Public Comment No. 244-NFPA 72-2023 [Section No. 18.3.7.1]

Updates to PI 542:

Public Comment No. 208-NFPA 72-2023 [Section No. 18.4.1.8]

Public Comment No. 20-NFPA 72-2023 [Section No. 18.4.3.2]

I. **Figure E – NAC CM Internal Block Diagram**

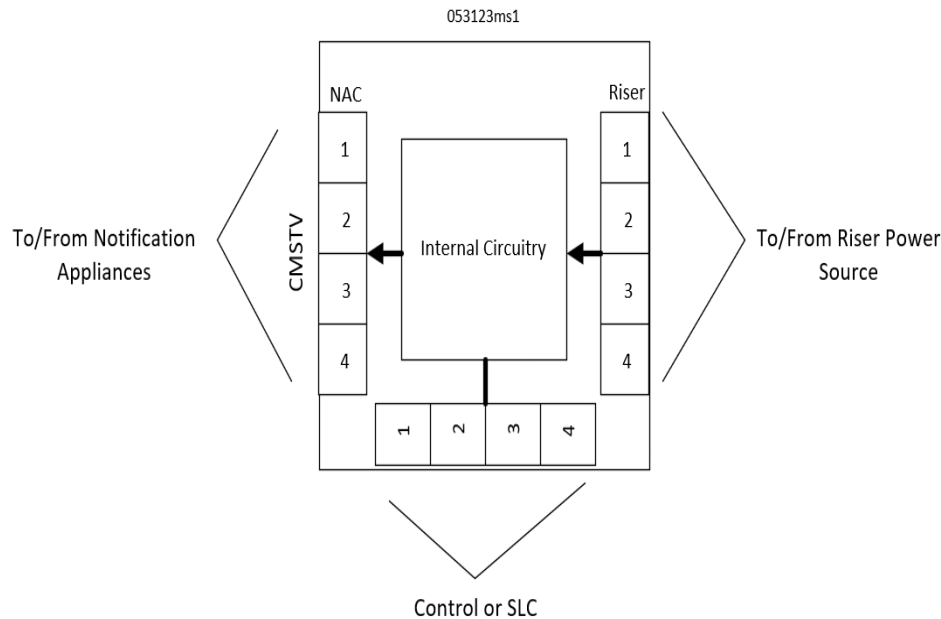
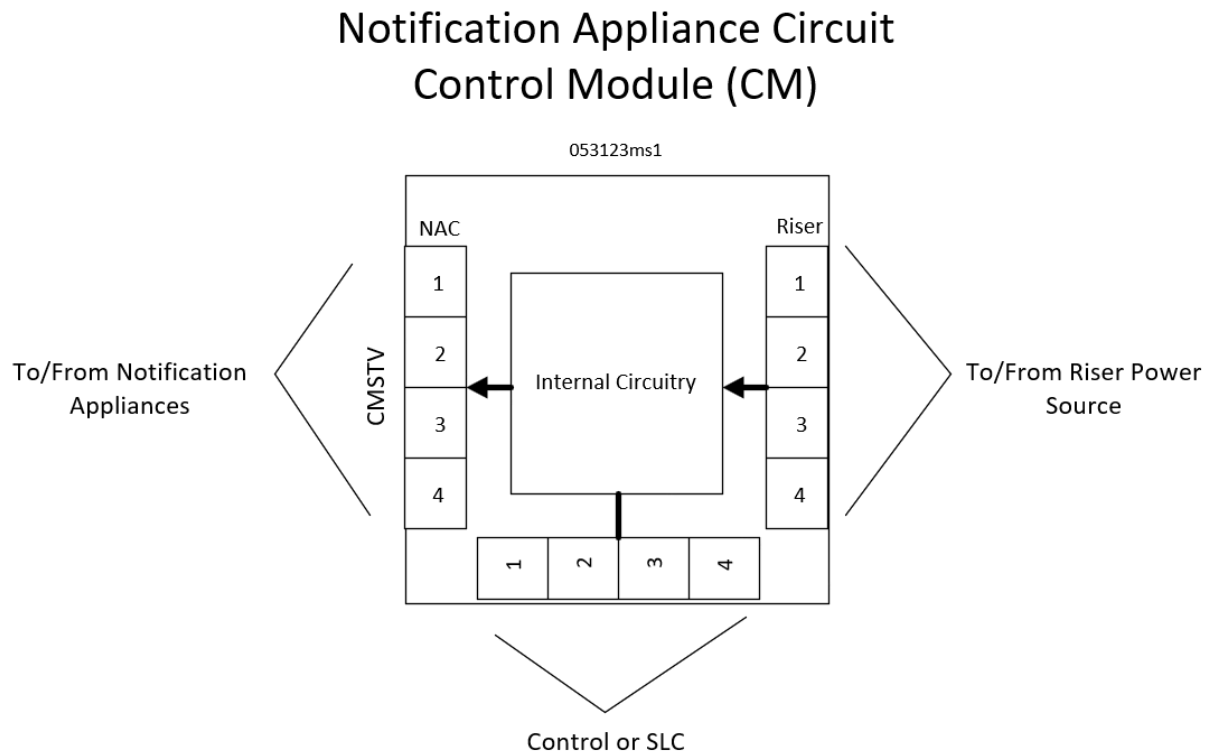
- (1) **Figure E** provides a block diagram of the internal sections of a typical DCNAC CM. The DCNAC CM may impact the voltage of the connected NAC. This is typically a voltage drop. Some may boost the voltage. In either case, in DCNACs, this is referred to as Module Voltage Adjustment (MVA) and must be accounted for in the overall system design.
- (1) Figure E – NAC CM Internal Block Diagram

1. **Figure E** provides a block diagram of the internal sections of a typical DCNAC CM. The DCNAC CM may impact the voltage of the connected NAC. This is typically a voltage drop. Some may boost the voltage. In either case, in

DCNACs, this is referred to as Module Voltage Adjustment (MVA) and must be accounted for in the overall system design.

Class A Measurement For Circuit Length

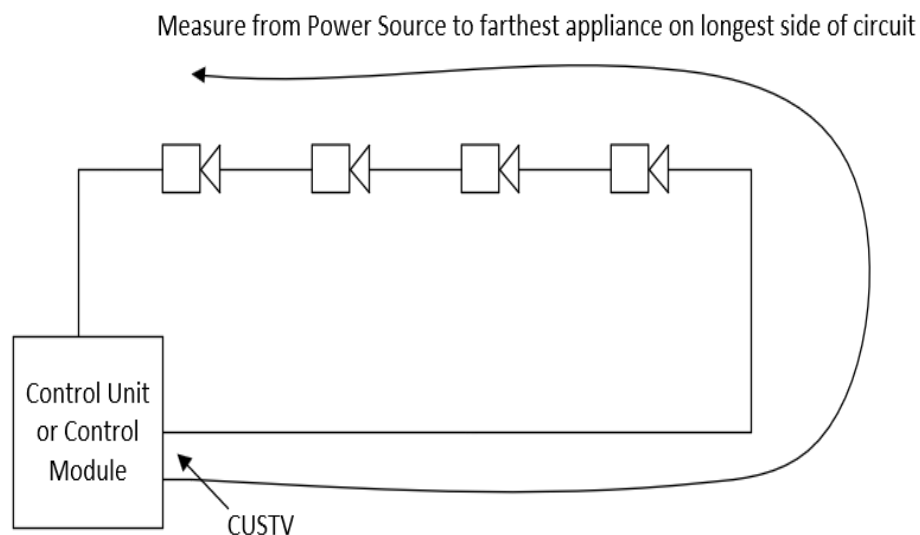
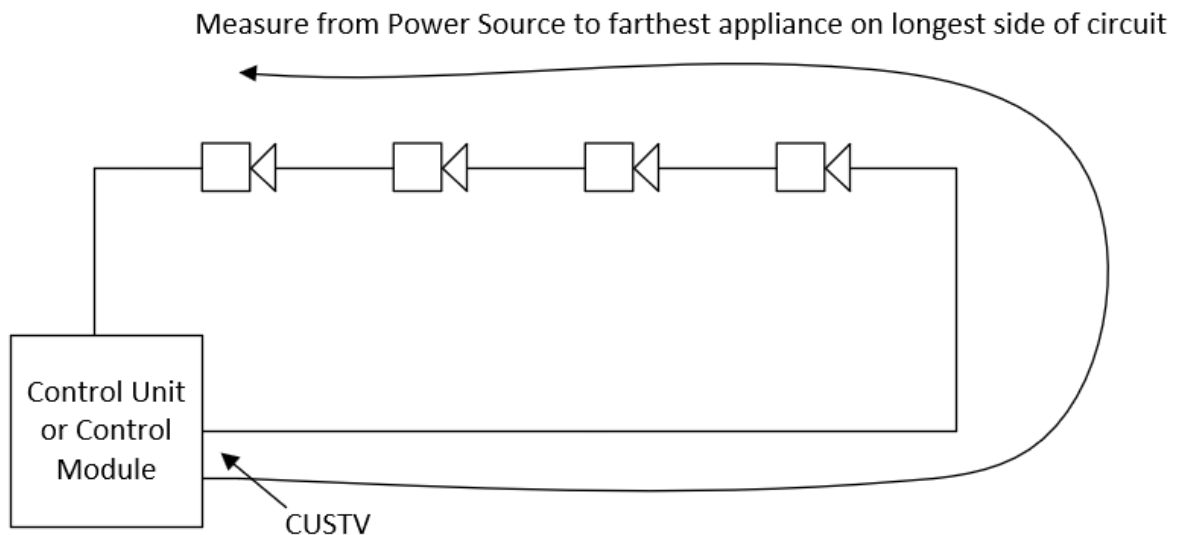
The following diagram depicts how to measure the circuit length for a Class A NAC:

DC NACS End-To-End Concept Diagram

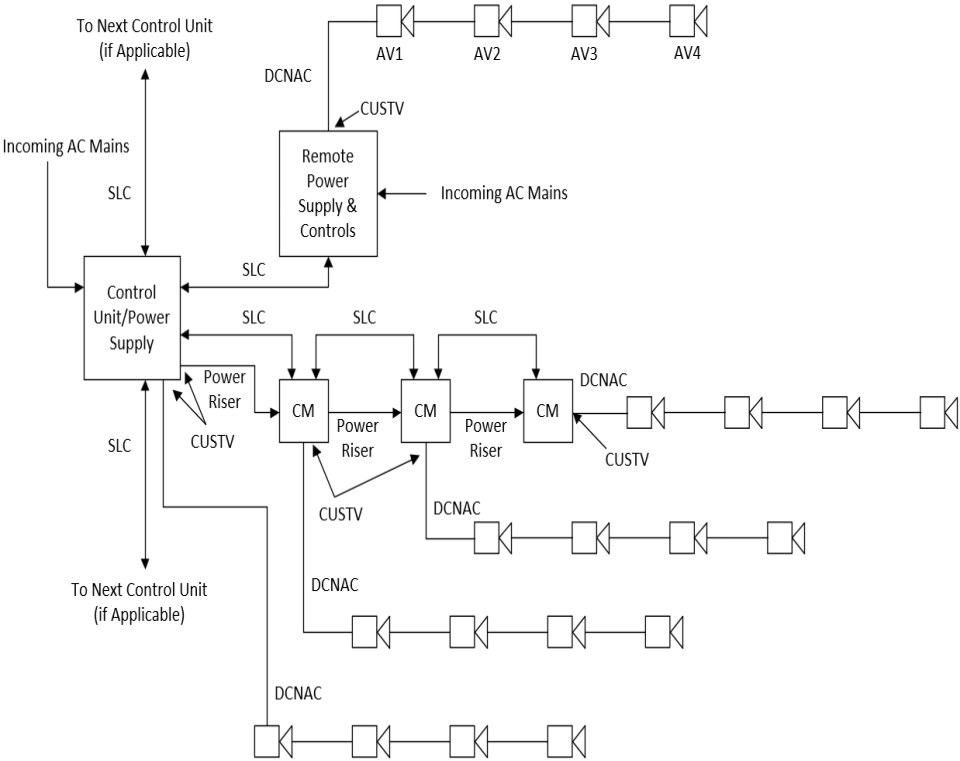
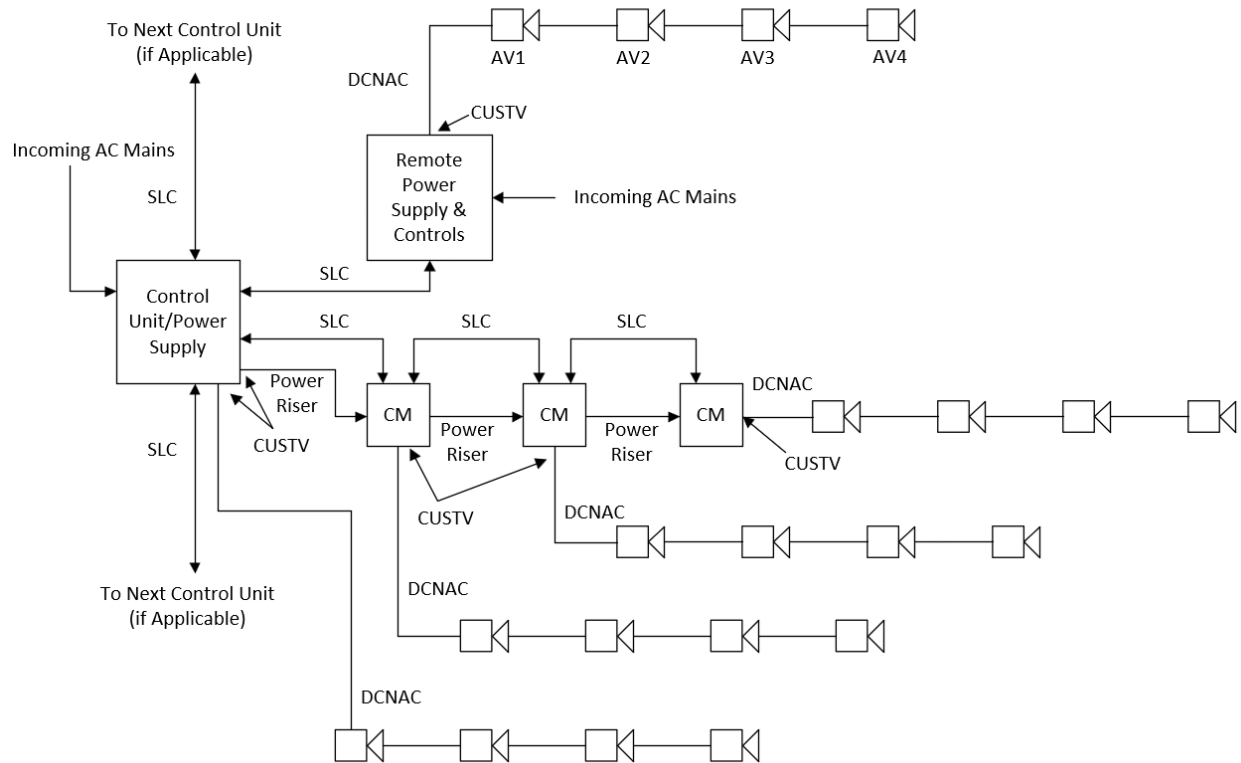
The following diagram depicts the overall power flow and areas of concern for a system:

Note – if the power riser is altered by the CM as the power comes in/out of the CM, that adjustment also needs to be included in the calculations.

Figure 18.4.3.2 Temporal Pattern Parameters — Carbon Monoxide Signal.

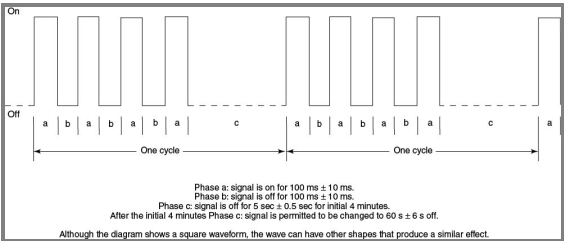
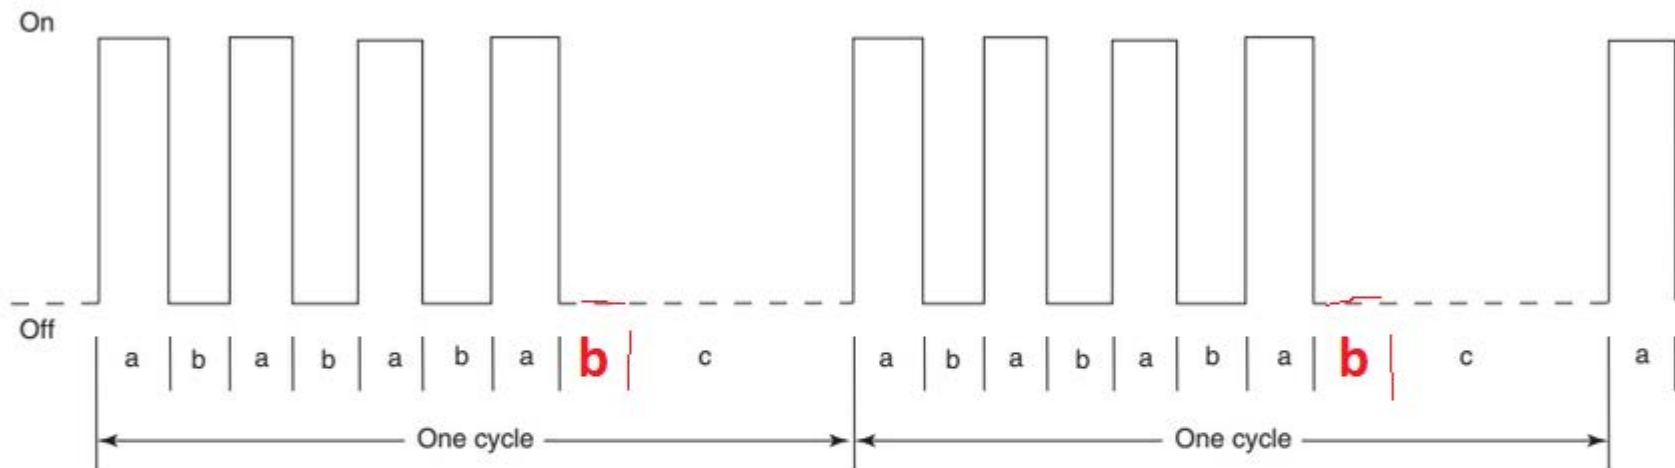
File Name	Description	Approved
NFPA72-18.4.3.2.png	The existing Figure 18.4.3.2 does not reflect the text of 18.4.3.2(1) accurately. Specifically, the text reads: Signals shall be a pattern consisting of four cycles of 100 milliseconds +- 10 percent "on" and 100 milliseconds +- 10 percent "off", followed by 5 seconds +- 10 percent "off", as demonstrated in Figure 18.4.3.2. The figure does not show 4 cycles of "on" and "off" followed by 5 seconds of "off", what the figure does show is 3 cycles of "on" and "off", followed by 100 milliseconds "on", followed by 5 seconds "off". The final 100 milliseconds "off" of the 4th cycle, before the 5 seconds "off", is missing from the figure. The attached image shows the missing 100 milliseconds "off" segment in red.

The existing Figure 18.4.3.2 does not reflect the text of 18.4.3.2(1) accurately. Specifically, the text reads:
Signals shall be a pattern consisting of four cycles of 100 milliseconds +- 10 percent "on" and 100 milliseconds +- 10 percent "off", followed by 5 seconds +- 10 percent "off", as demonstrated in Figure 18.4.3.2.

The existing figure does not show 4 cycles of "on" and "off" followed by 5 seconds of "off". What the figure does show is 3 cycles of "on" and "off", followed by 100 milliseconds "on", followed by 5 seconds "off".

The problem is the final 100 milliseconds "off" of the 4th cycle, before the 5 seconds "off", is missing from the figure. The attached image shows the missing 100 milliseconds Phase b "off" segment in red.
